# Access Compliance Report

## Public Rights-of-Way

### (Curb Ramps)

Intersection ID: 43371	Main Street: BERNARDY_LN	Cross Street: SIMONTON_DR	Location: NE
ADA ID: 602A33437720	Ramp Type: PerpDiag	Initial Pass/Fail: Fail	Overall Compliance: No
		Severity Score: 12.5

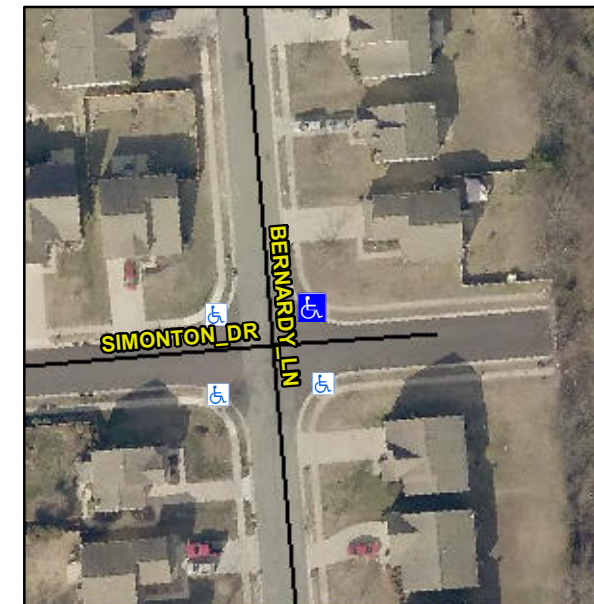
**Not Found, R304.2.2**

Compliance	Description	Data	Compliance	Description	Data
N/A	Ramp Length (in)	47.0	No	Ramp Slope (%)	8.4
Yes	Ramp Width (in)	48.0	Yes	Ramp XSlope (%)	0.5
N/A	Flare Type LT	N/A	N/A	Flare Type RT	N/A
N/A	Flare Slope LT (%)	N/A	N/A	Flare Slope RT (%)	N/A
N/A	Flare Traversable LT?	N/A	N/A	Flare Traversable RT?	N/A
N/A	Landing Length (in)	N/A	N/A	DWS Provided?	N/A
N/A	Landing Width (in)	N/A	N/A	DWS Contrast?	N/A
N/A	Landing Slope (%)	N/A	N/A	DWS Length (in)	N/A
N/A	Landing X Slope (%)	N/A	N/A	DWS Full Width?	N/A
N/A	Landing Curb? (Y/N)	N/A	N/A	DWS Offset (in)	N/A
N/A	Shared Landing?	N/A			
N/A	Gutter Ponding?	N/A	N/A	Gutter Slope (%)	N/A
N/A	Gutter Lip Ht (in)	N/A	N/A	Gutter X Slope (%)	N/A
N/A	Painted X Walk1?	No	N/A	Painted X Walk2?	No
	X Walk 1 Direction	To W		X Walk 2 Direction	To S
N/A	X Walk 1 Width (in)	N/A	N/A	X Walk 2 Width (in)	N/A
	X Walk 1 Slope (%)	0.1		X Walk 2 Slope (%)	0.8
	X Walk 1 X Slope (%)	0.2		X Walk 2 X Slope (%)	3.3

**Remove & Replace Curb Ramp With Two New Directional Ramps or Equivalent.**
